Office Action Summary

10/502,460

DETAILED OFFICE ACTION

FIG. 1

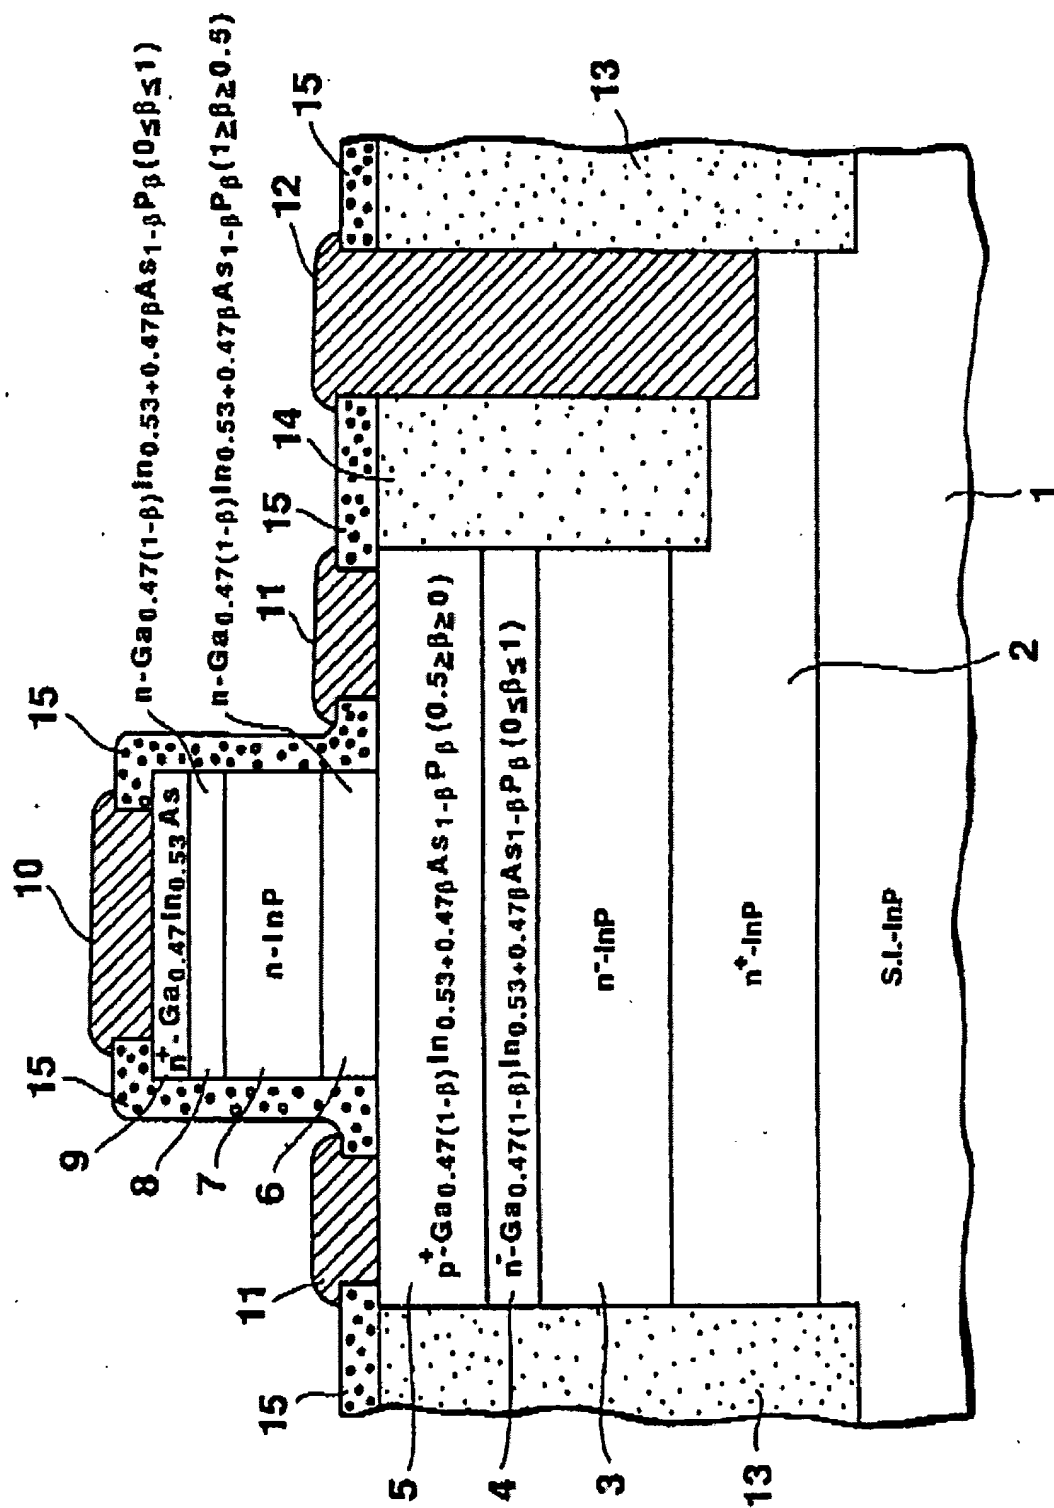
Katoh discloses (in fig 1, fig 4, column 1 line 6-67, particularly line 6-12 and line 44-49) a heterobipolar transistor (column 3 lines 20-30), comprising an emitter which includes a first semiconductor layer (fig 1 layer 9," made of a first semiconductor material and a second semiconductor layer (fig 1 layer 7) made of a second semiconductor material, a band gap value of the first semiconductor material being smaller than a band gap value of the second semiconductor material, characterized in that a semiconductor intermediate layer (fig 1 layer 8) made of an intermediate layer semiconductor material is disposed between the first semiconductor layer and the second semiconductor layer (and that a band gap value of the intermediate layer semiconductor material is greater than the band gap value of the first semiconductor material and smaller than the band gap value of the second semiconductor material.(column 3 lines 20-30) .

Katoh discloses a heterobipolar transistor, characterized in that the first semiconductor material comprises InGaAs (Katoh fig 1 layer 9, "GaInAs"), the second semiconductor material comprises InP (Katoh fig 1 layer 7), and the intermediate layer semiconductor material comprises InGaAsP (Katoh fig 1 layer 8, "GaInAsP").

Katoh discloses a heterobipolar transistor characterized in that the first semiconductor layer is contacted metallicity. Noted that layer 9 in fig 1 of Katoh reference corresponds to first

semiconductor layer 9 PCT document of the applicant and is metallically contacted with layer 10. which is made with gold (Au) (see Katoh reference column 7 line 47) and gold is metal.

Katoh discloses (in fig 1, column 1 line 6) a heterobipolar transistor characterized in that a further semiconductor layer (Katoh layer 6 fig. 1), borders on the second semiconductor layer 5, at a side remote from the semiconductor intermediate layers (layers 7,8 fig 1) and that the further semiconductor layer (Katoh fig 1 layer 6) borders on a base (5).
